Instruction #10

Re-work of Tail Wheel Shock Absorber Plate

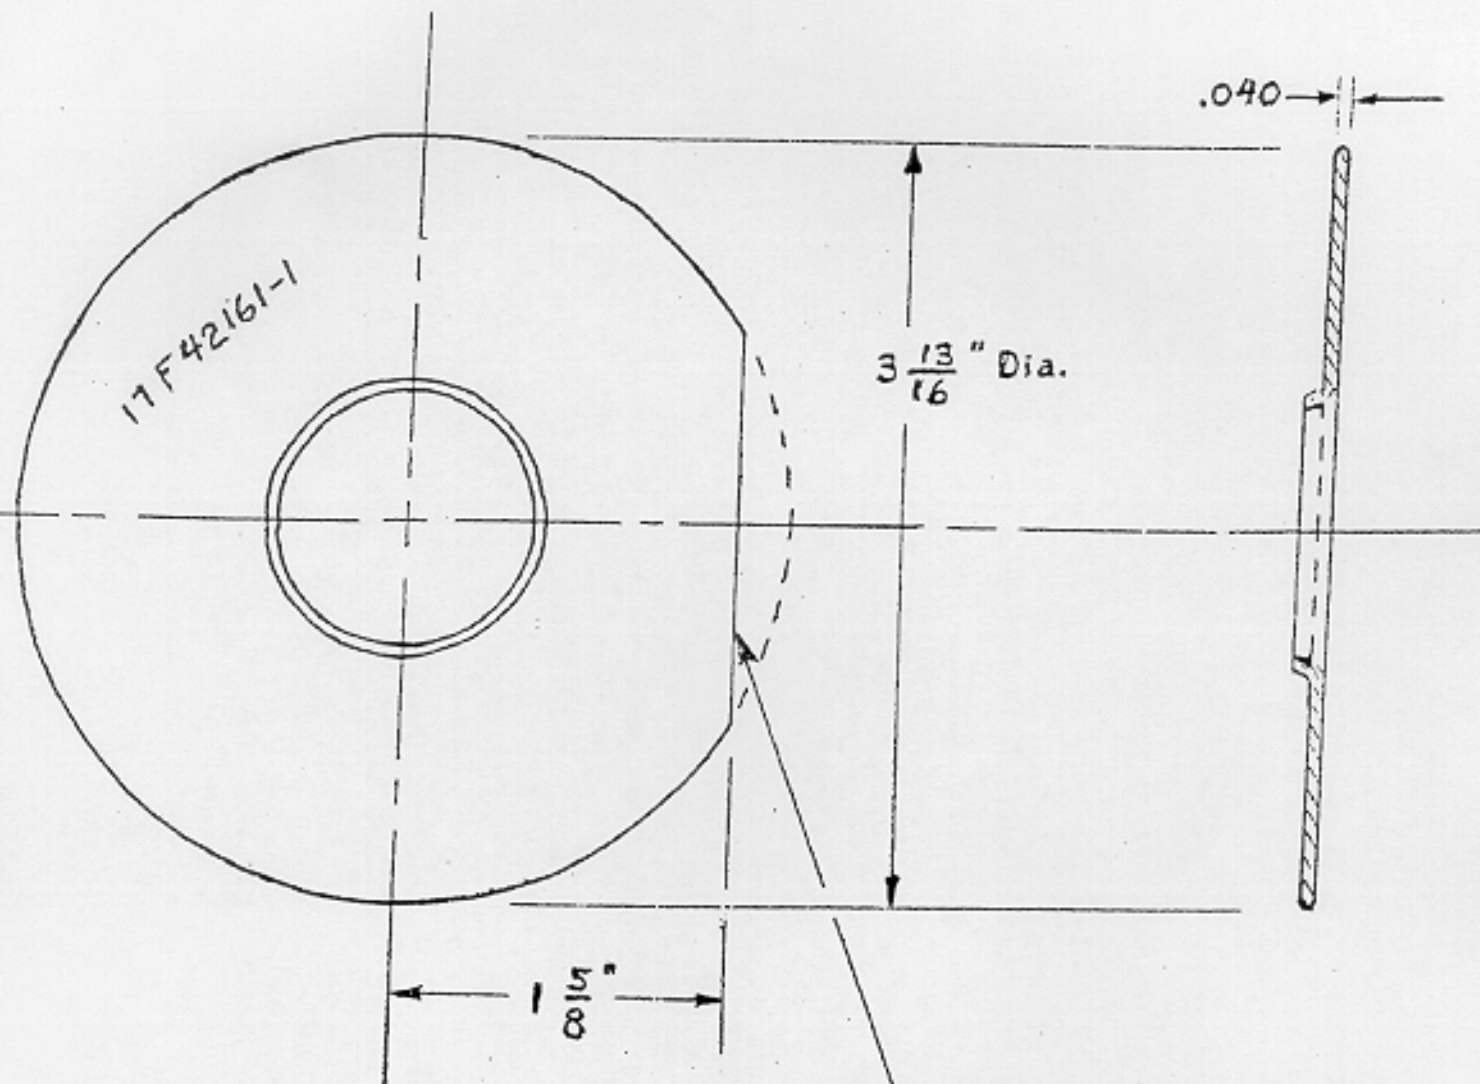
If this item (1129) is to be used on ships 1 thru 125, the 17F42161-1 metal plate must be cut as shown in sketch below. If used for ships 125 and up, no rework is necessary.

Trim edge of plate
to dimension as shown.
